**[Docket No. 2000-CE-44-AD; Amendment 39-12920; AD 2002-21-13]**

### **Airworthiness Directives; Raytheon Aircraft Company Beech Models 35, 35R, A35, and B35 Airplanes**

**ACTION:** Final rule.

**Figure 1**

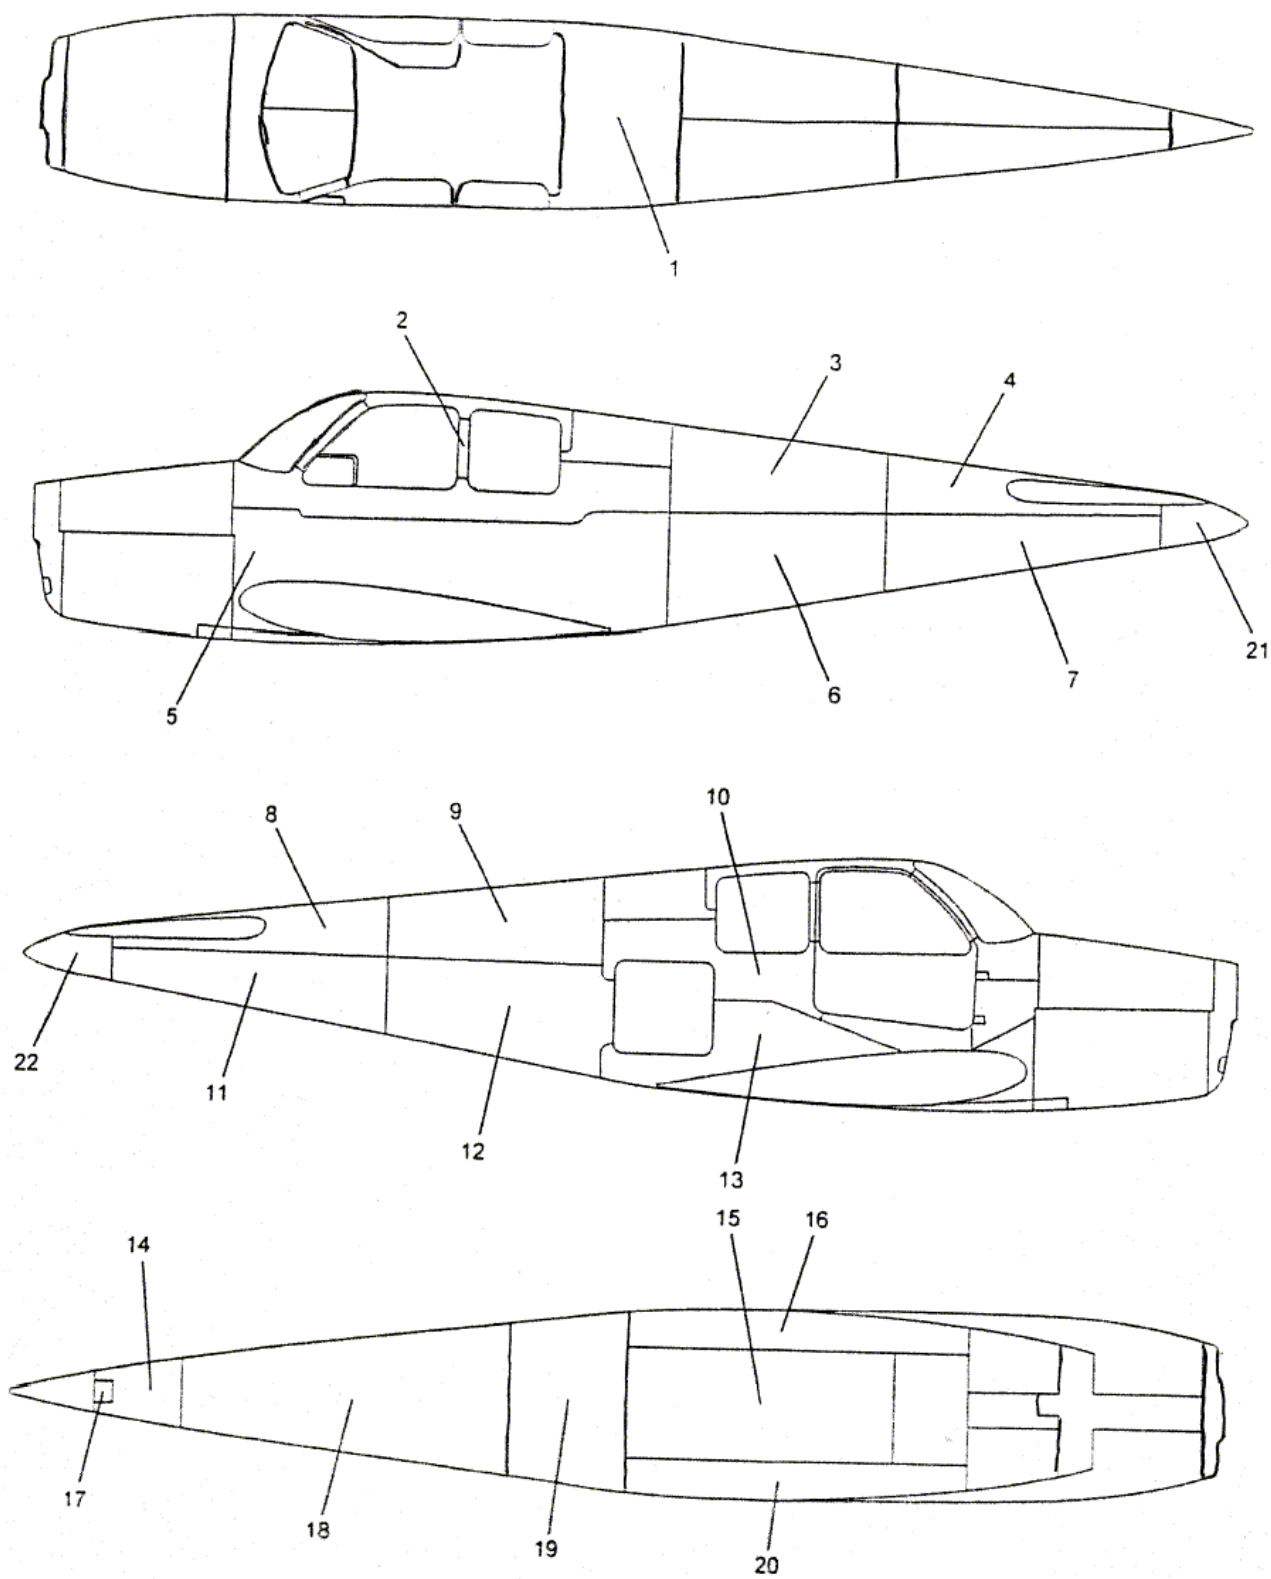
Several commenters present the same concern with the equipment used to measure skin thickness as that concern with the propeller balancing. That concern is specifying only one piece of equipment. These same commenters also state that there are differences in skin thickness, e.g., 0.016 inch instead of 0.018 inch.

We also concur that there are differences in skin thickness. We are adding to the final rule AD action reference to the different skin thicknesses that are specific to each airplane serial number and the location (fuselage stations) of each affected skin part number.

(5) Visually inspect the empennage, aft fuselage, and ruddervator control system for damage: (i) Part of this is an inspection of the aft fuselage skin for wrinkles or cracks. Specific skin thicknesses are presented in Figures 1 and 2 of this AD. The skin thickness measurement is not repetitive. (ii) The inspection and setting of the travels on the elevator and elevator trim tabs are not repetitive. (iii) Repair or replace any damaged parts and set the elevator controls, rudder and tab system controls, cable tensions, and rigging.	Inspect within the next 100 hours TIS after the last inspection required by AD 94-20-04 or within the next 25 hours TIS after December 10, 2002 (the effective date of this AD), whichever occurs later, and thereafter at intervals not to exceed 100 hours TIS, except for the skin thickness measurement and the inspection and setting of the travels on the elevator and elevator trim tabs, which are one-time actions. Accomplish any repairs, replacements, and adjustments prior to further flight after the applicable inspection.	Accomplish the inspection and repairs or replacements in accordance with the procedures in paragraphs (5)(a) through (5)(f) of the ACCOMPLISHMENT INSTRUCTIONS section of Raytheon Service Bulletin No. SB 27-3358, Issued: February, 2000, and use a digital ultrasonic skin tester or equivalent skin tester or direct methods that utilize calipers and micrometers. Specific skin thicknesses are contained in Figures 1 and 2 of this AD.
